East Anglia ONE North and East Anglia TWO Offshore Windfarms

Applicants' Comments on SEAS' Deadline 9 Submissions

Applicant: East Anglia TWO and East Anglia ONE North Limited
Document Reference: ExA.AS-13.D10.V1
SPR Reference: EA1N_EA2-DWF-ENV-REP-IBR-001063

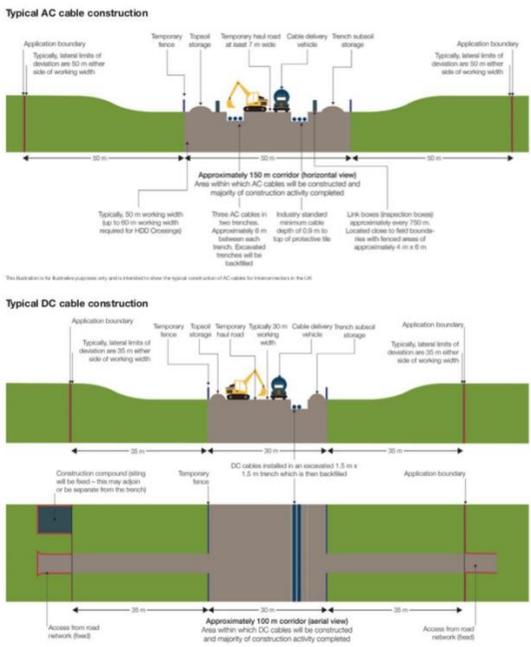
- On ecological survey coverage, the Applicants would note that within the Applications the extended Phase 1 habitat survey results (APP-277) are

presented for the Order limits only. The 2018 and 2019 surveys in fact covered the indicative onshore development area and the Order limits as presented on **Figure 4.5** of the Environmental Statement (ES) (APP-085).
